July 23, 2018

Subject: Comments on draft Clean Water Act section 401 water quality certification related to the decommissioning of the Lower Klamath Project (FERC Project no. 14803)

Sediment Load Quantification:

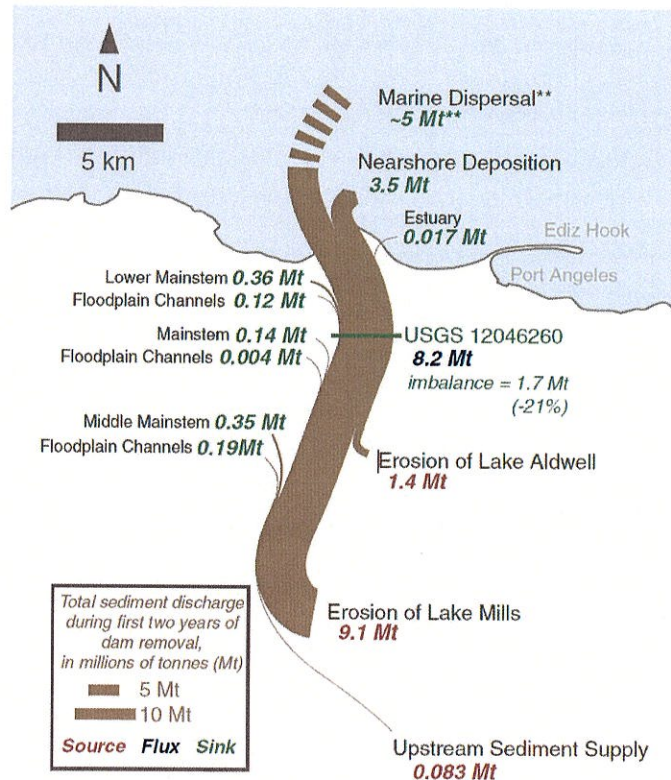
Page 17. We suggest expanding and clarifying this section. In addition to what is already stated in this section (i.e., quantifying erosion and deposition), we suggest that the continuous turbidity data and suspended sediment samples be combined with continuous flow data to estimate continuous sediment loads (i.e., continuous transport). These sediment loads and estimates of erosion and deposition should then be used to construct reach-scale and basin-scale sediment budgets, similar to what was done for the Elwah River dam removal (Warrick et al. 2015):
